SPLIT RIM WHEELS HAVE SPLIT

Due to safety concerns, the old HEMTT split rim wheels are no longer available. You now have to order a new two-piece, bolt-together wheel.

Hubs with three 0.62-in bosses need rework

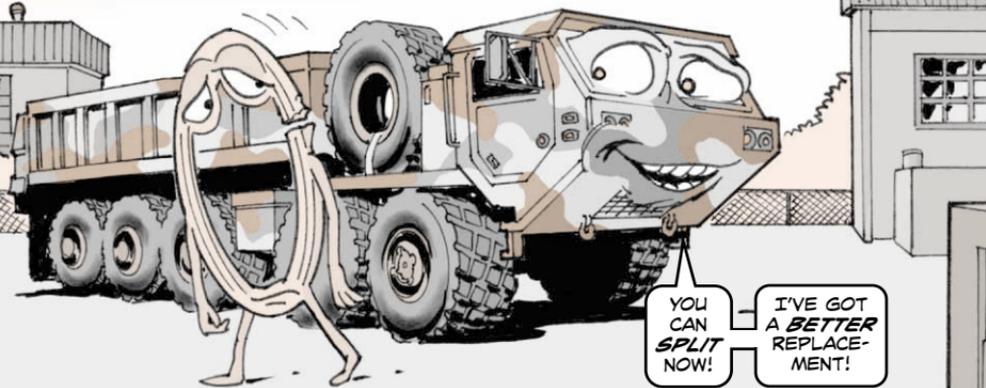
Early-production non-wrecker HEMTTs have three 0.62-in bosses on the rear axle hubs. These bosses should be reworked by DS to avoid interference when installing the bolt-together rims. The procedure is on Page 11-4.1 of TM 9-2320-279-34-2 (Jun 87 w/Ch 3).
